**CITY OF KELOWNA**  
**MEMORANDUM**

APPLICATION NO. Z02-1046

AT: 2260-2270 HAYNES RD

PURPOSE: TO REZONE THE SUBJECT PROPERTY TO THE RM6 –  
HIGH RISE APARTMENT HOUSING ZONE TO PERMIT THE  
CONSTRUCTION OF AN APARTMENT HOUSING  
DEVELOPMENT

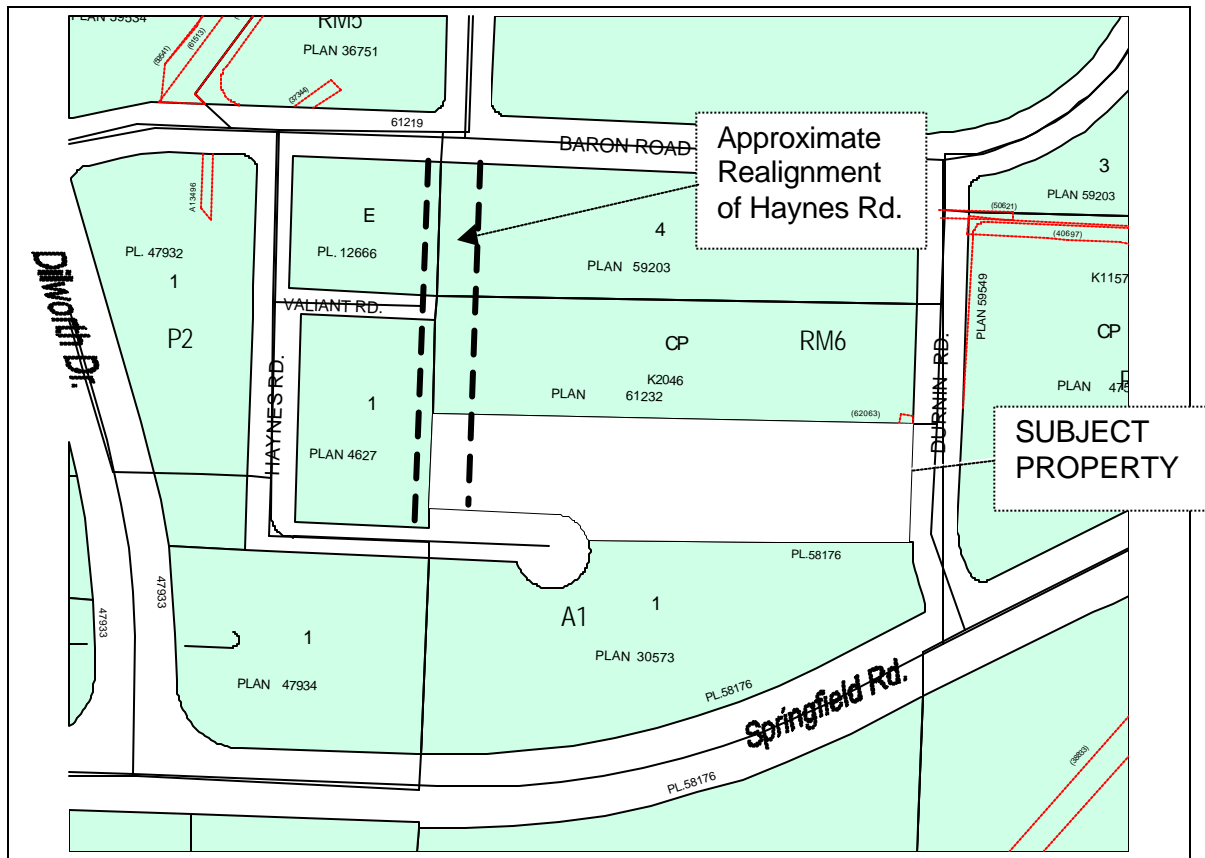
The parkade structure encroaches the front yard setback from Haynes Rd. (the parking structure is proposed to be located entirely below grade)

These building are considered "High Building" and are subject the requirements of Section 3.2.6 of the BCBC

It has also become apparent through the plan review that the proposed daylight angle to the south property line of 74° does not comply to the zoning bylaw requirement of a maximum of 65°. It will be necessary for the applicant to apply for a Development Variance Permit to address this issue. Staff have supported variances to the daylighting standards for other projects in this area and are not overly concerned with this variance issue. The applicant anticipates making application for a Development Variance Permit to address the issue of the daylight angle prior to final adoption of the zone amending bylaw.
